Reviewer Responses to HESS comments re:

## **Leveraging a time-series event separation method to untangle time-varying hydrologic controls influence on wildfire disturbance on streamflow**

**\*\*The comments from ESP and the reviewers are in black and our responses in blue.**

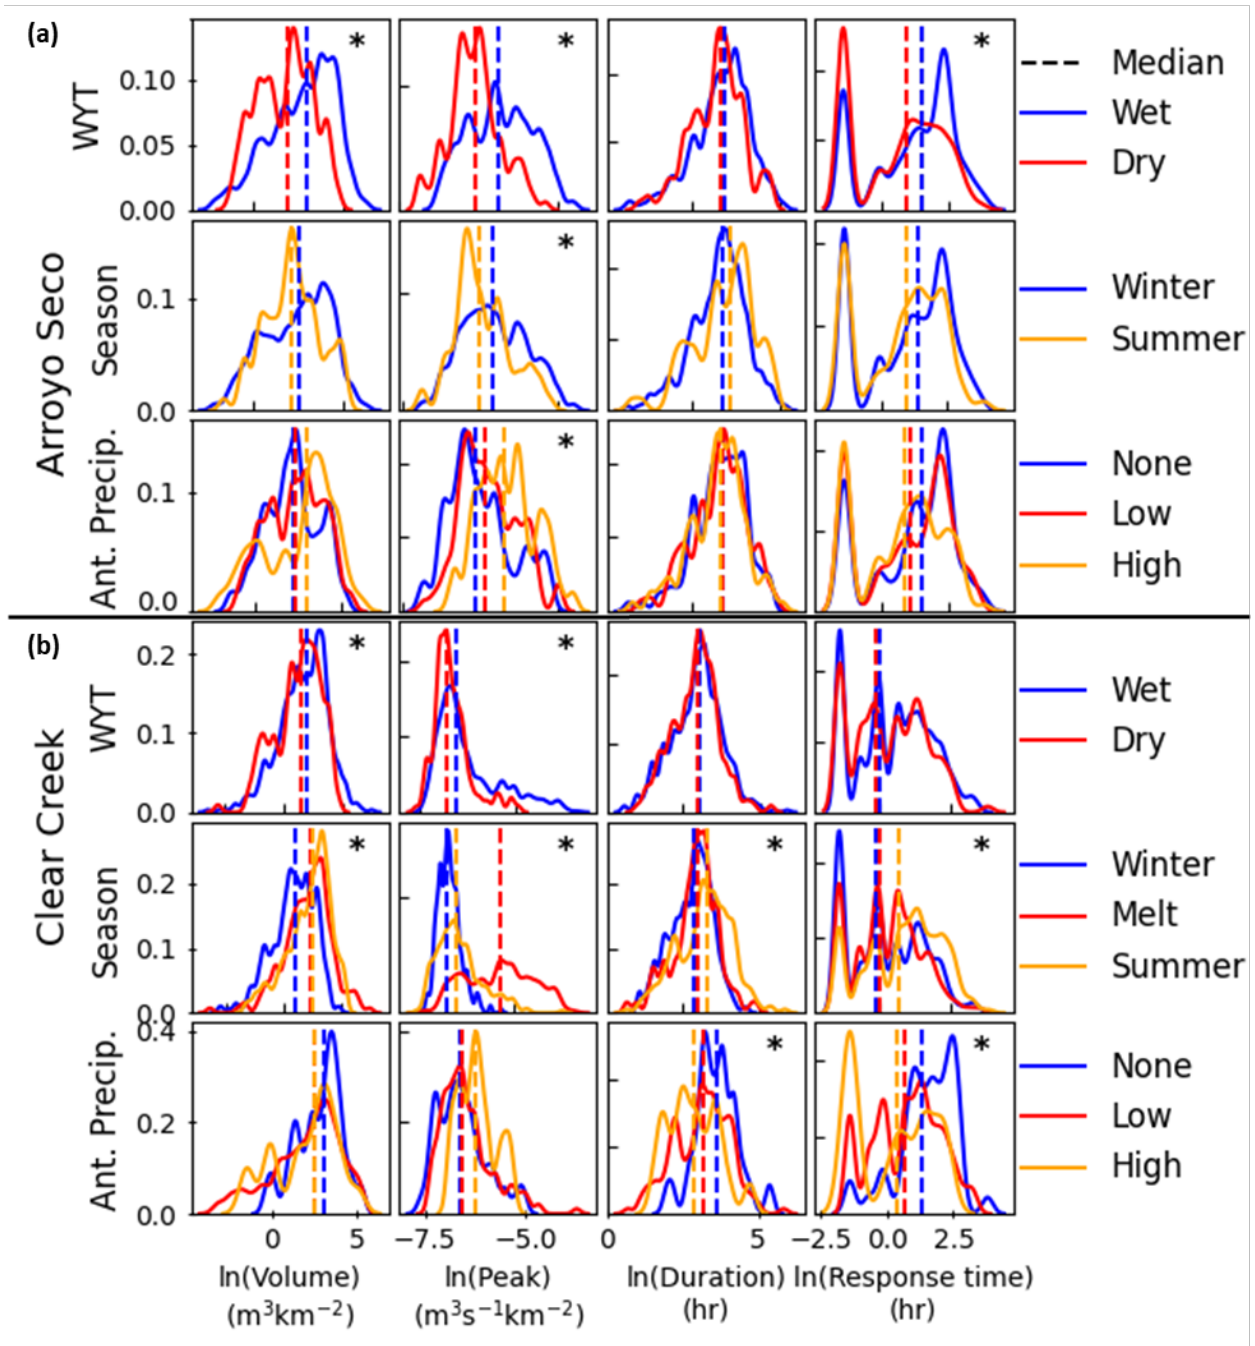
6. Figure 6: Can you explain what negative values on the x-axis for volume, peak flow and response time mean?

Plotted values are representative of the natural log (ln) of the volume, peak, duration, and response time metrics. As such, values can be negative if less than 1. We have updated the figure so that this is noted appropriately in the x-axis labels. We have clarified this is the natural log transform in the Fig. 6 caption.
